Application No.: **DA2025293**

Location: **5-7 Cassia Drive, Ulverstone**

Proposal: **Consolidation of lots; and Residential - multiple dwellings x 4**

## Response to Request for Further Information DA2025293 - Boundary Adjustment, Residential - multiple dwellings x 4 - 5-7 Cassia Drive, ULVERSTONE

**PAGE TITLE SITE PLAN - PROPOSED**

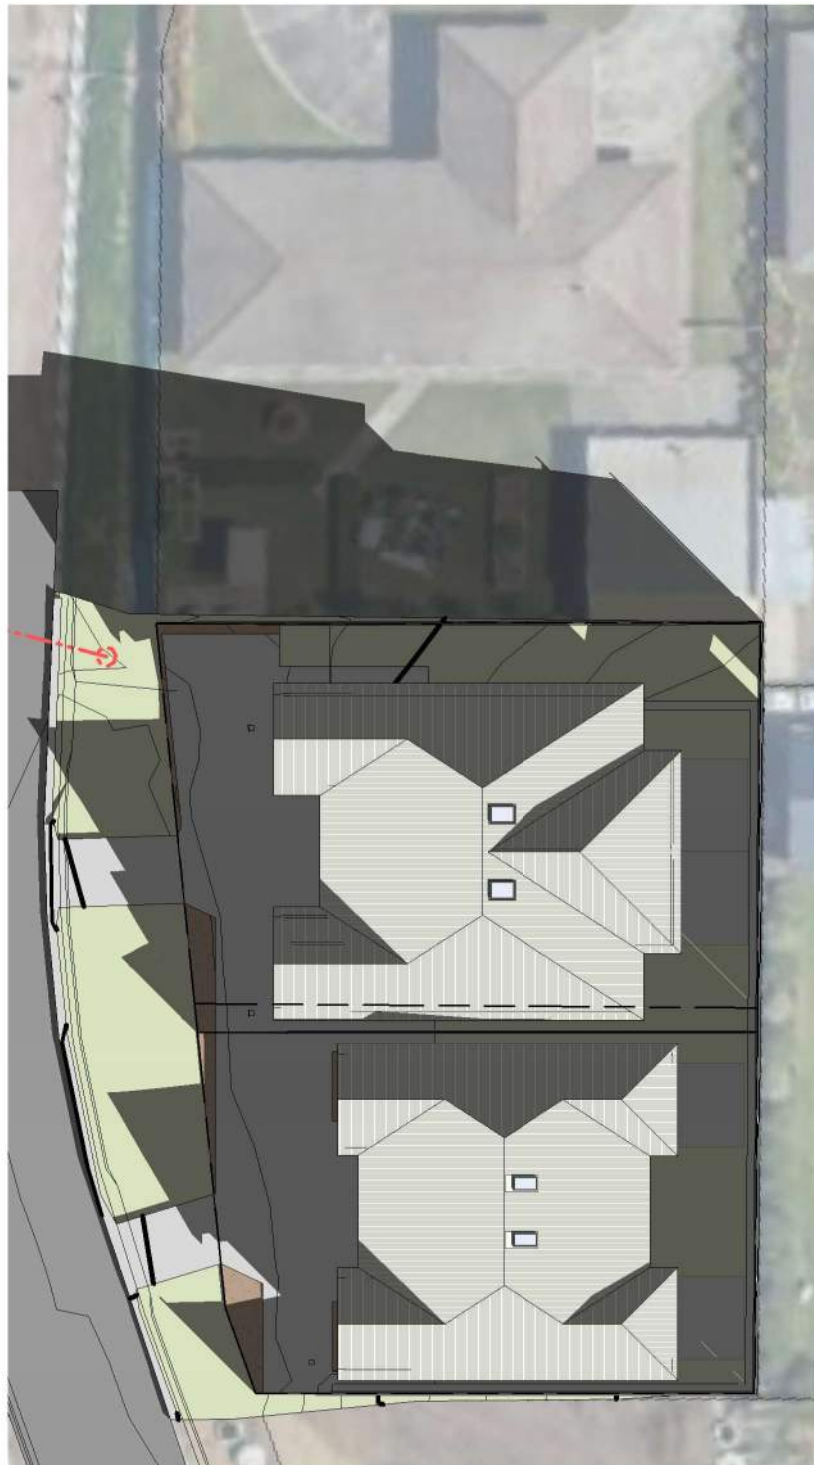
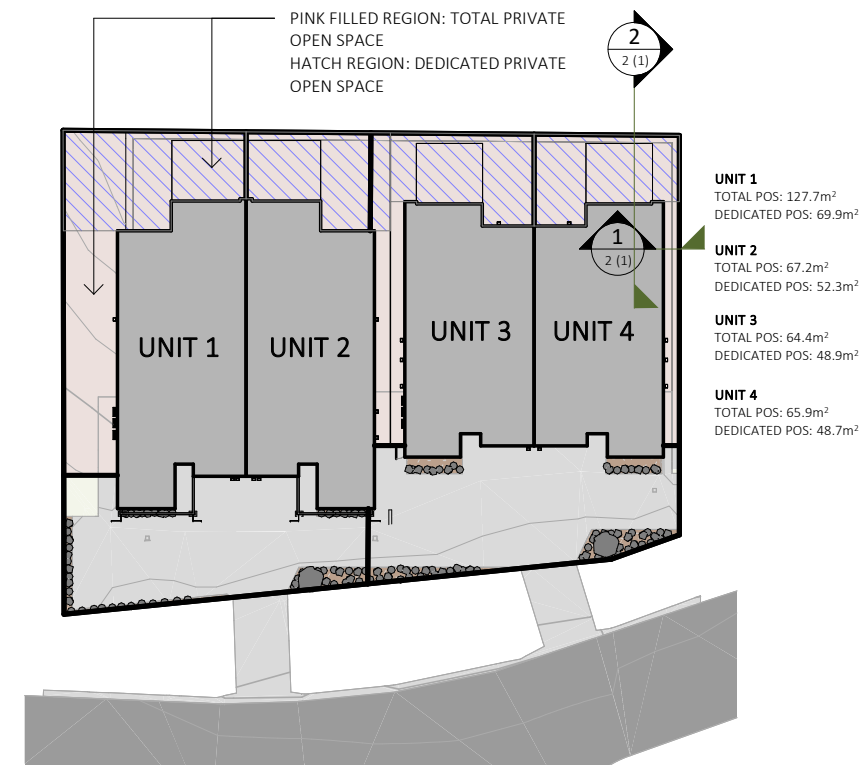
**3** - Please provide a calculation for site coverage this needs to include driveways and non-permeable surfaced areas.

**Point 7 - Crossover requirements-** *If the applicant intends to combine the lots into one and proceed with the submitted plan, they will need to remove one of the proposed crossovers. Council only permits either:*

*The proposed plan currently shows two 6 m wide crossovers, which is not acceptable*

**Response** – Please see the updated Development Application design plans provided

**Response -** Please see the updated Development Application design plans provided which show 2 x 3.6m crossovers and updated parking manoeuvres suitable for the crossovers

**STRIP FOOTING, BLOCKWORK & BLOCKWORK CONTROL JOINT PLAN**

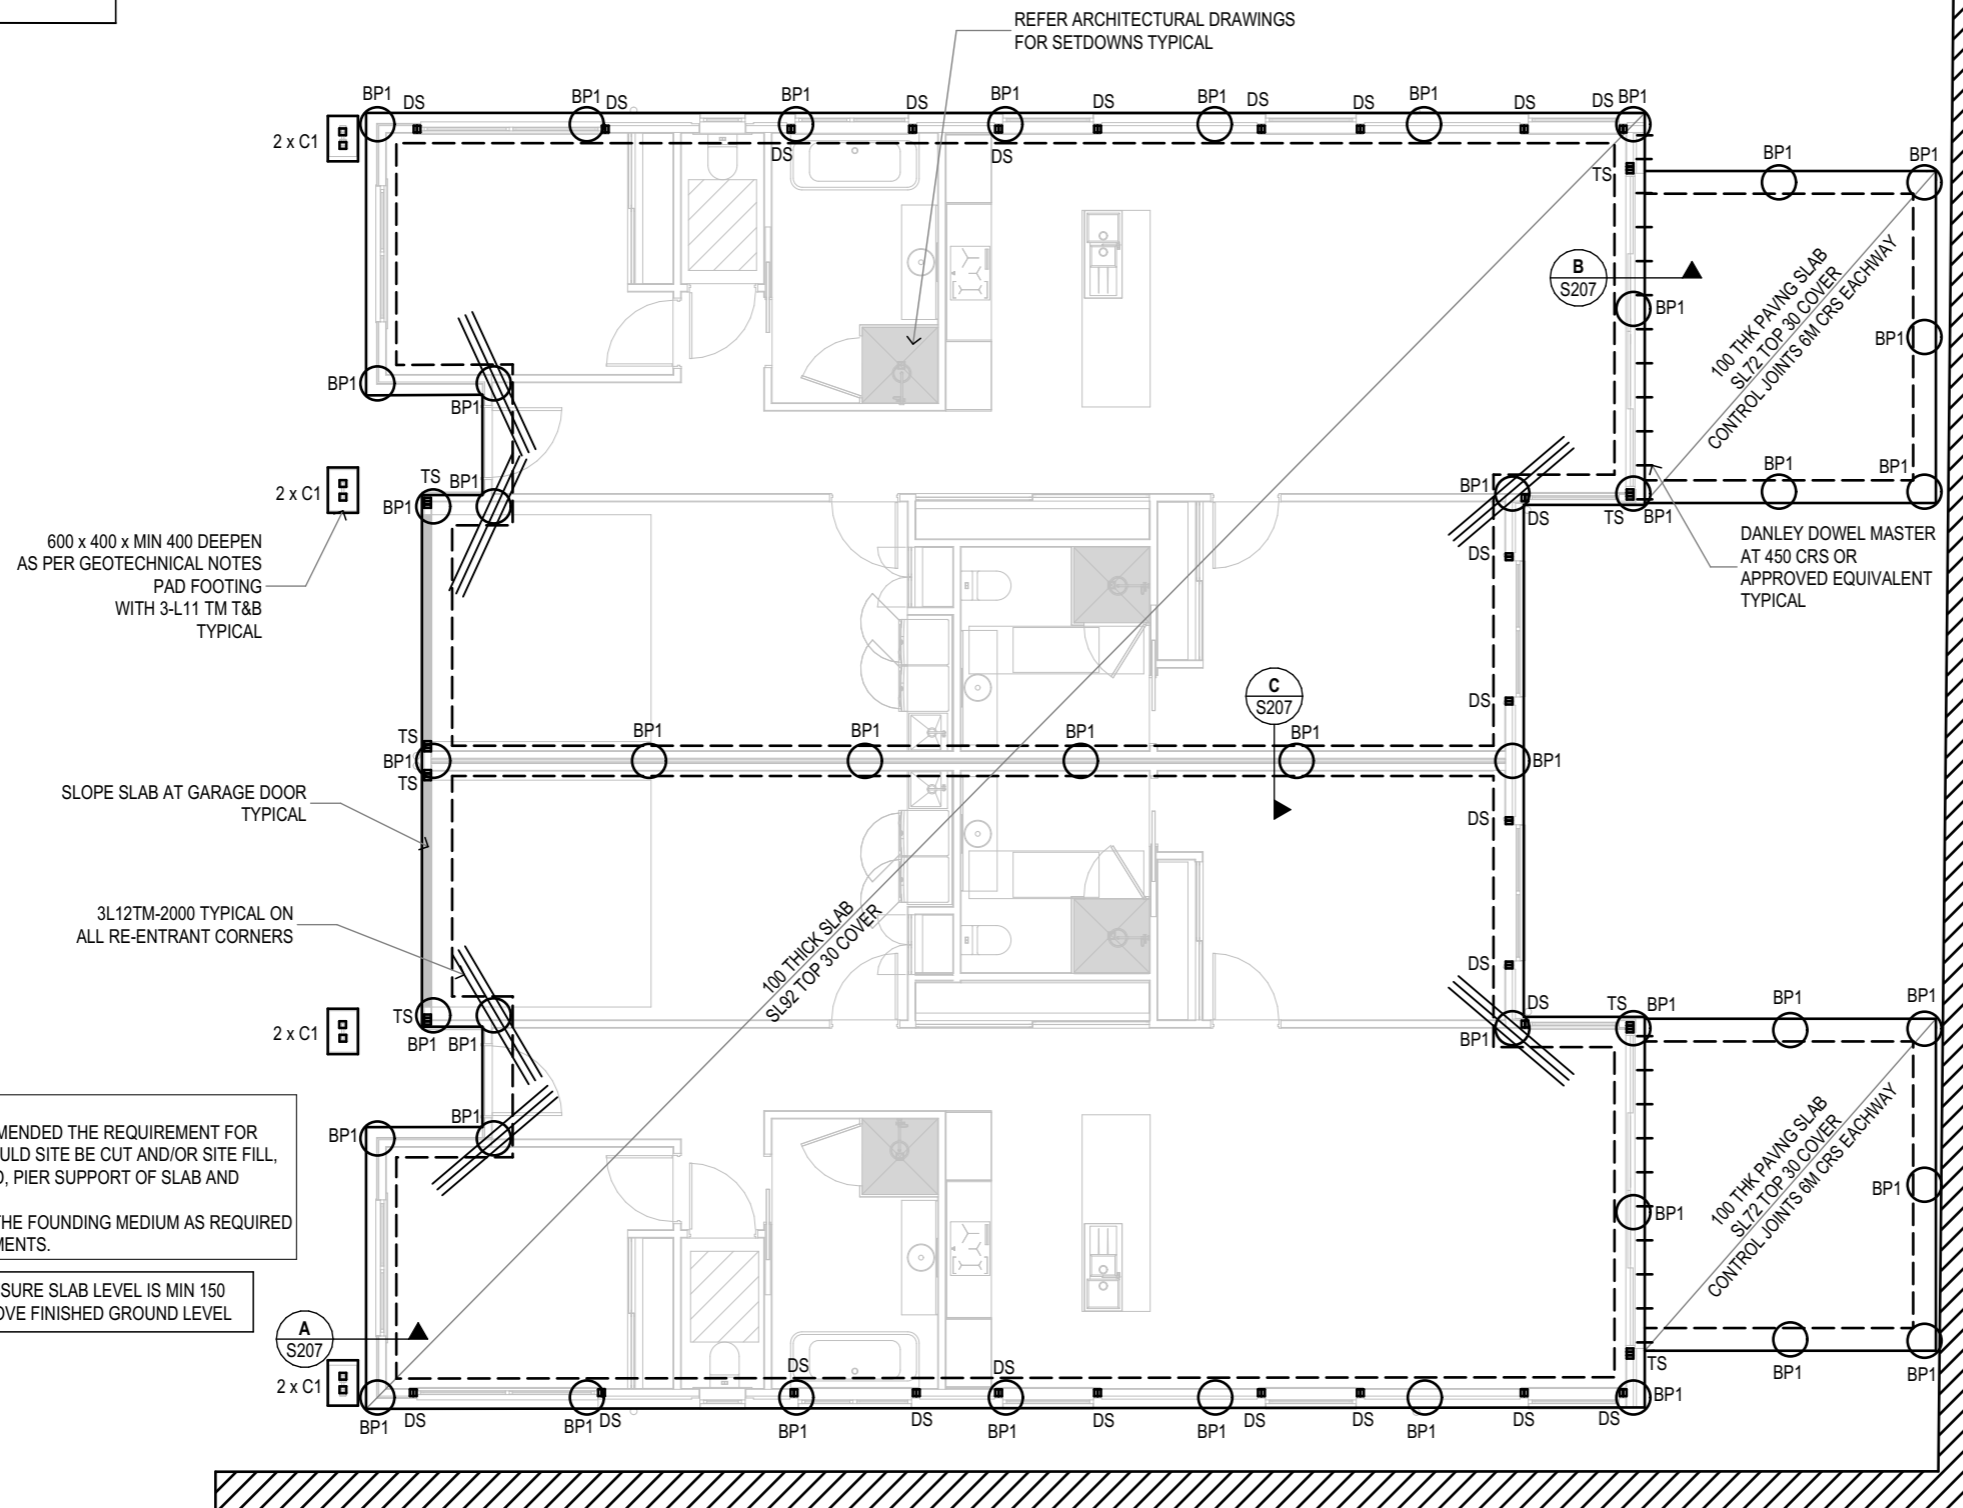
**6** - The proposed plans show the retaining walls are within 1.5m of the boundary and will require assessment against 7.10 of the planning scheme.

*The site plan depicts retaining walls on the North and East of the Site. Due to the setback to boundary, the retaining wall will be reliant on Section 7.0 General Provisions, 7.10 'Development Not Required to be Categorised into a Use Class of the planning scheme. Plans and documentation demonstrating that there would be no unreasonable detrimental impact on adjoining uses or amenity of the surrounding area is required.*

*Under General Provision 7.10 to demonstrate no 'unreasonable detrimental impact on adjoining uses or amenity of the surrounding area' – we will need to see plans and documentation showing the level of impact on any adjoining properties, particularly the lot to the East demonstrating any impact to the existing or future use of that site and adjoining uses near that boundary. This can be provided via a statement by an engineer addressing 7.10*

The proposed retaining walls for unit development at 5 & 7 Cassia Drive, Ulverstone, are considered to comply with the intent of Clause 7.10 of the Planning Scheme.

**Response** – Please see the engineering documentation provided

SITE STORMWATER DESIGN  
 5 AND 7 CASSIA DRIVE, ULVERSTONE  
 SITE STORMWATER PLAN

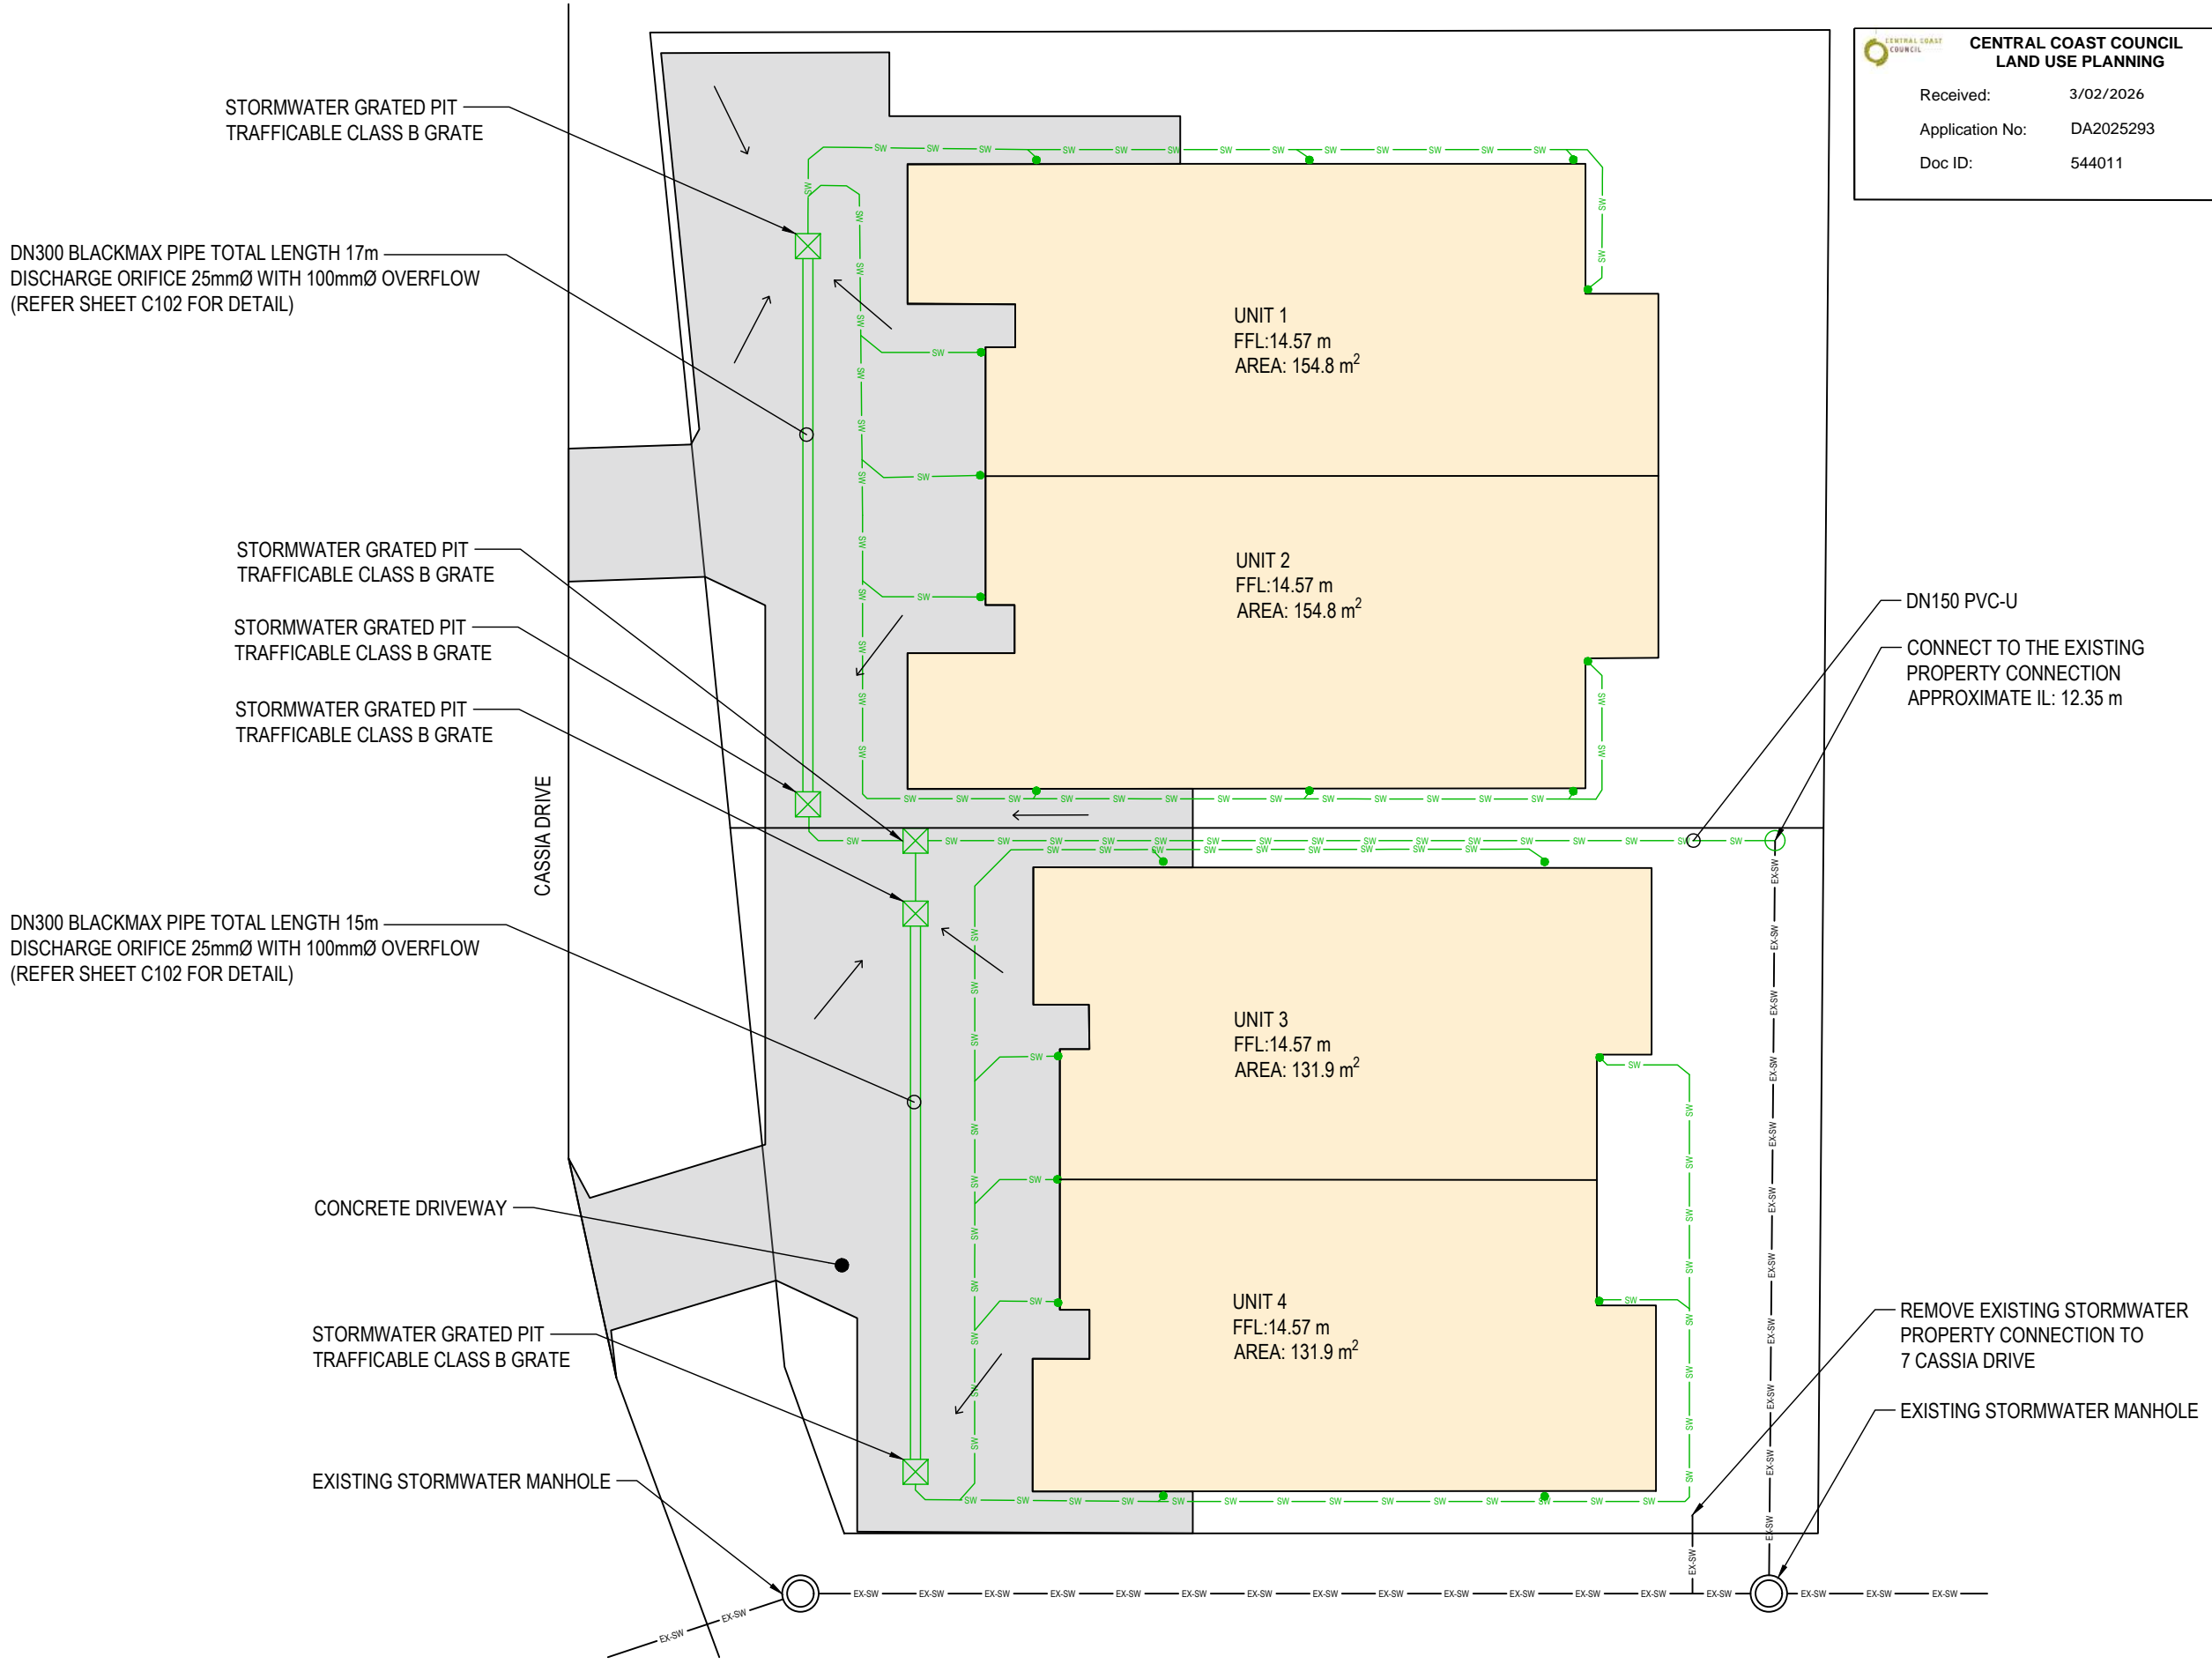
*If the development is proposed on two separate lots, they must use separate stormwater connections for each lot. The submitted plan only shows one stormwater connection, which is not compliant.*

**Response –** As the property is to be conjoined, there will only be a requirement for one property connection
